Access Compliance Report

Public Rights-of-Way

Intersection ID: 45689	Main Street: ALOYSIA_LN	Cross Street: CANIPE_FARM_CT	Location: NE
ADA ID: 4BDDE230526C	Ramp Type: PerpDiag	Initial Pass/Fail: Fail	Overall Compliance: No
		Severity Score: 10

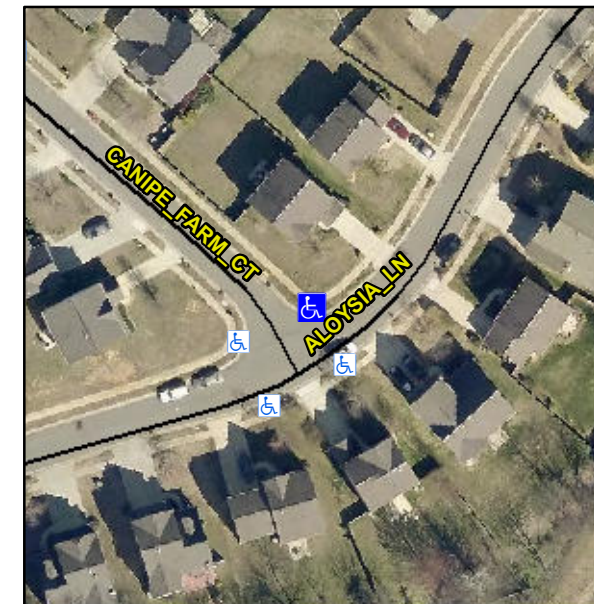
Not Found, R304.5.1, R304.5.3

Compliance	Description	Data	Compliance	Description	Data
N/A	Ramp Length (in)	47.5	Yes	Ramp Slope (%)	5.9
No	Ramp Width (in)	39.0	No	Ramp XSlope (%)	2.8
N/A	Flare Type LT	N/A	N/A	Flare Type RT	N/A
N/A	Flare Slope LT (%)	N/A	N/A	Flare Slope RT (%)	N/A
N/A	Flare Traversable LT?	N/A	N/A	Flare Traversable RT?	N/A
N/A	Landing Length (in)	N/A	N/A	DWS Provided?	N/A
N/A	Landing Width (in)	N/A	N/A	DWS Contrast?	N/A
N/A	Landing Slope (%)	N/A	N/A	DWS Length (in)	N/A
N/A	Landing X Slope (%)	N/A	N/A	DWS Full Width?	N/A
N/A	Landing Curb? (Y/N)	N/A	N/A	DWS Offset (in)	N/A
N/A	Shared Landing?	N/A			
N/A	Gutter Ponding?	N/A	N/A	Gutter Slope (%)	N/A
N/A	Gutter Lip Ht (in)	N/A	N/A	Gutter X Slope (%)	N/A
N/A	Painted X Walk1?	No	N/A	Painted X Walk2?	No
	X Walk 1 Direction	To W		X Walk 2 Direction	To S
N/A	X Walk 1 Width (in)	N/A	N/A	X Walk 2 Width (in)	N/A
	X Walk 1 Slope (%)	3.5		X Walk 2 Slope (%)	0.8
	X Walk 1 X Slope (%)	0.4		X Walk 2 X Slope (%)	3.6

Remove & Replace Curb Ramp With Two New Directional Ramps or Equivalent.
